**ADDENDUM TO THE
MITIGATED NEGATIVE DECLARATION
THE GROVE PROJECT
SCH# 2016122048**

APRIL 28, 2017

**Town of Loomis
3665 Taylor Road
Loomis, CA 95650**

**De Novo Planning Group
1020 Suncastr Lane, Suite 106
El Dorado Hills, CA 95762**

Figure 2. Modified Drainage Plan

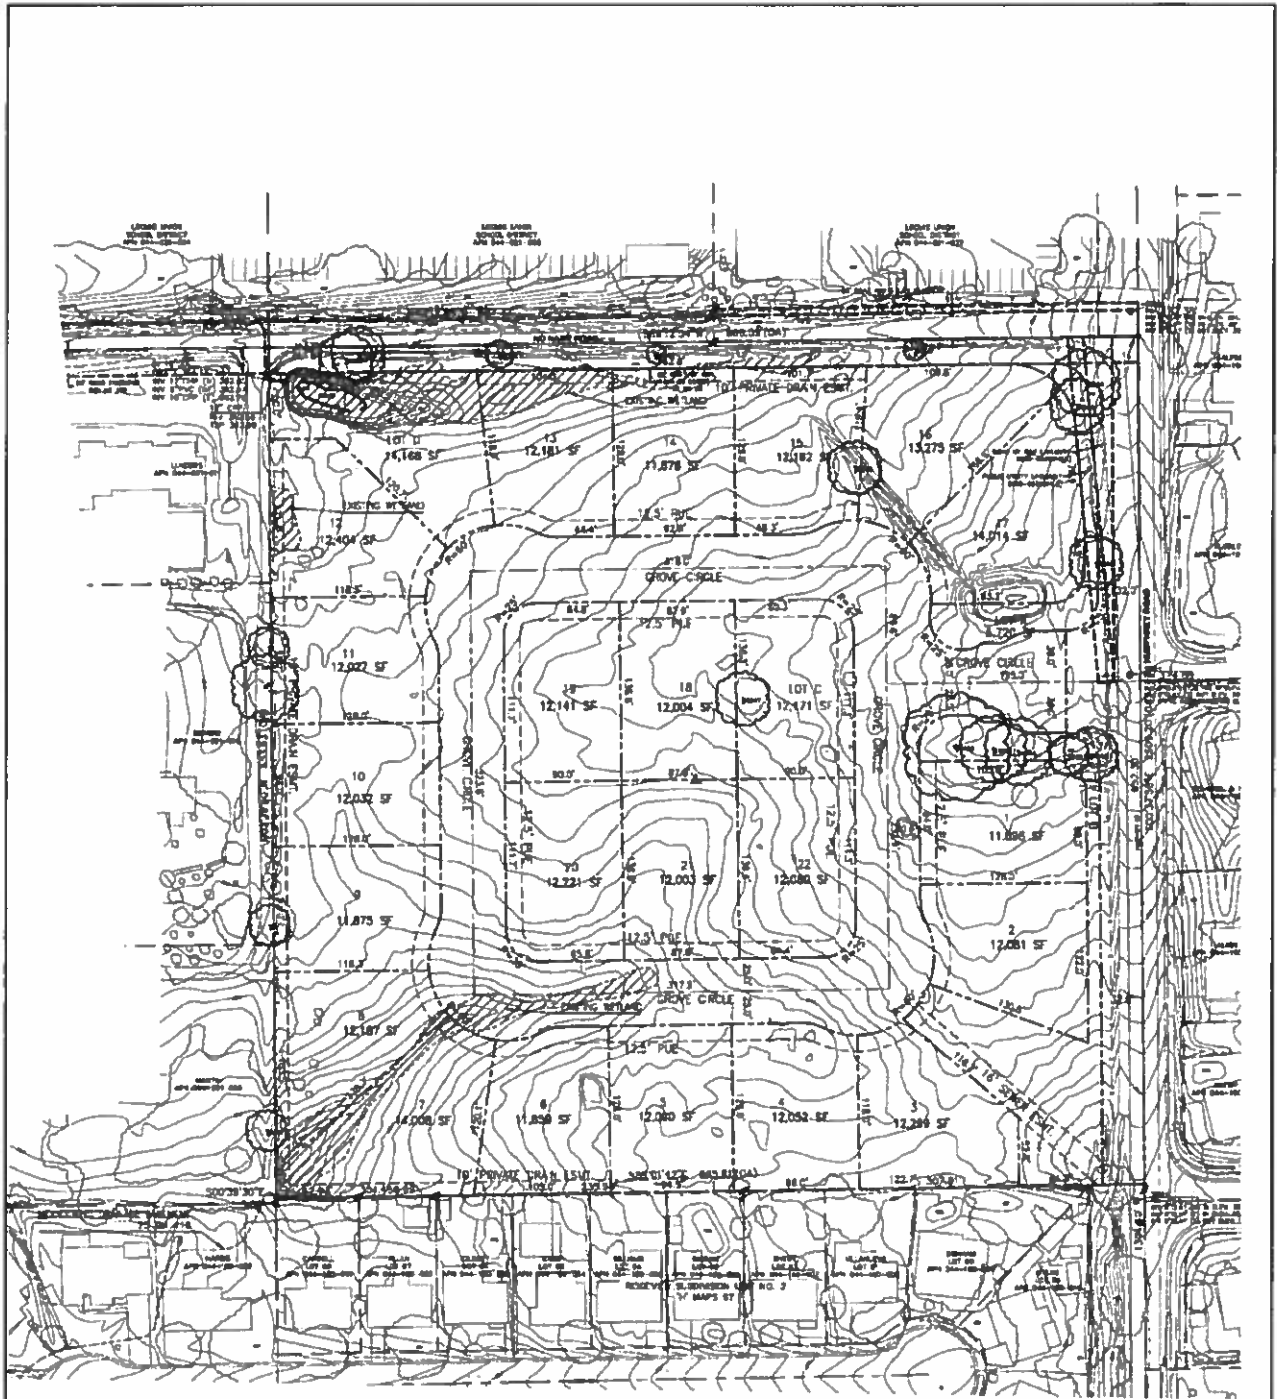
The proposed drainage of the site has been reconfigured in the Modified Project to reduce the total area draining to No Name Road, as compared with the Original Project. In the Original Project, onsite drainage from entire project site would be conveyed to a detention basin at the northwest corner of the site, which would then discharged to No Name Road. The proposed drainage for the Modified Project would be distributed to three discharge locations to match the existing drainage discharge points of the property.

The Preliminary Storm Drain Report, updated by Meredith Engineering in April 2017 to address the Modified Project, describes the existing drainage conditions and proposed storm drain system. The proposed storm drain system for the project would divide the site into three drainage sheds (Shed 1, Shed 2, and Shed 3), as shown in Figure 2. Drainage from these shed areas would be conveyed into a storm drain system, to address 10-year and 100-year storm events.

Under 10-year storm conditions, stormwater from Sheds 1 and 3 on the project site would flow from the residential, landscaping, and park lots toward Grove Circle. Stormwater would be collected and conveyed by 12-inch storm drain pipes within Grove Circle, which would be sufficient to convey a 10-year event. This stormwater would flow by gravity through these pipes to the stormwater detention basins located in the northwest (Lot D) and southeast (Lot B) areas of the site. Stormwater from Shed 2 would be collected and conveyed in rear yard ditches in the residential lots. Shed 2 would discharge at the existing discharge point to the adjacent property in the southwest corner.

THE GROVE IS/MND
Figure 1. Modified Site Plan

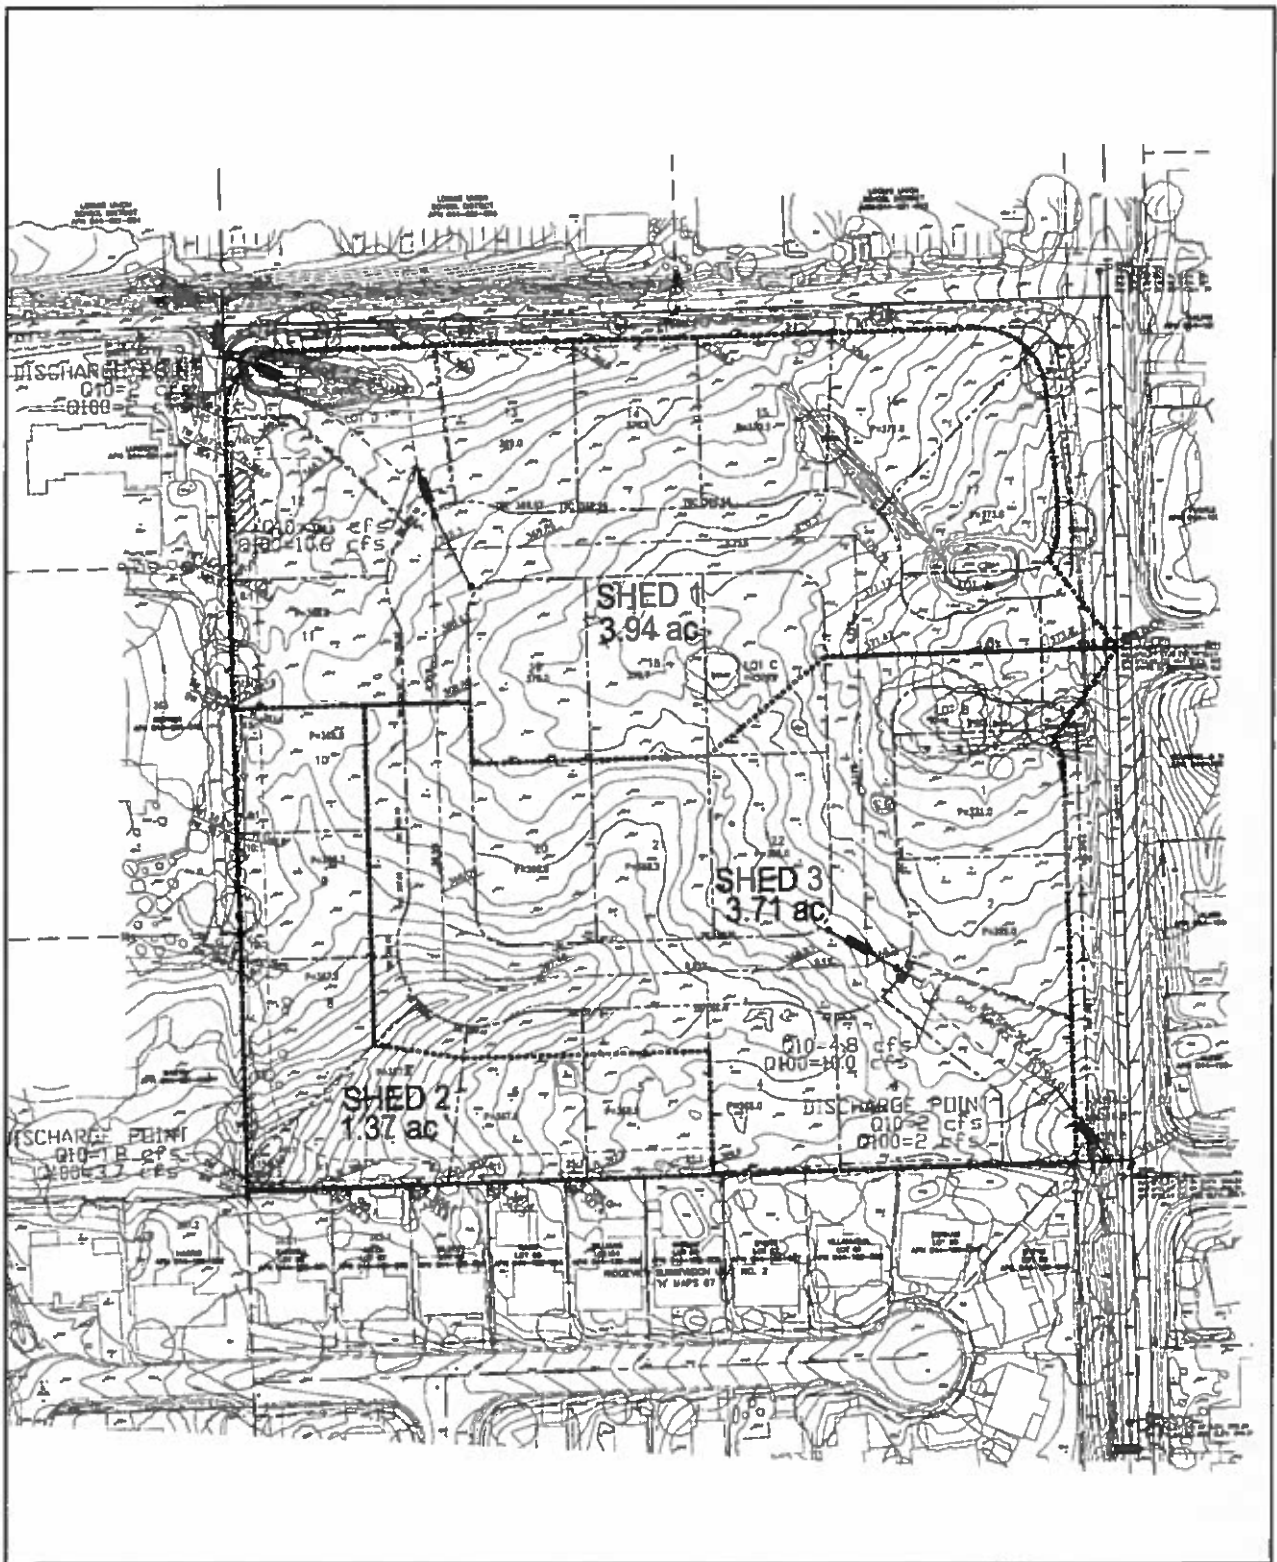
The Modified Project would revise the Original Project as shown in Table 1. The Site Plan for the Modified Project is provided as Figure 1. The Modified Project would result in a change to the grading and drainage plans, with resulting changes in runoff from the project site, and changes in the retaining wall height. As shown in Table 1, there are no other changes to the Original Project.

The modifications to the site plan and project layout result in minor changes to the size of the residential lots, increase the size of Lot B to accommodate a stormwater detention basin and sewer easement, and decrease the size of Lot D due to the revised drainage plan. These changes do not increase the density or intensity of the development, do not result in any significant changes to the layout of the project, and would not change the acreage developed by the project. Therefore, this change would not result in any new significant environmental impacts and would not increase the significance of environmental impacts analyzed in The Grove Mitigated Negative Declaration.
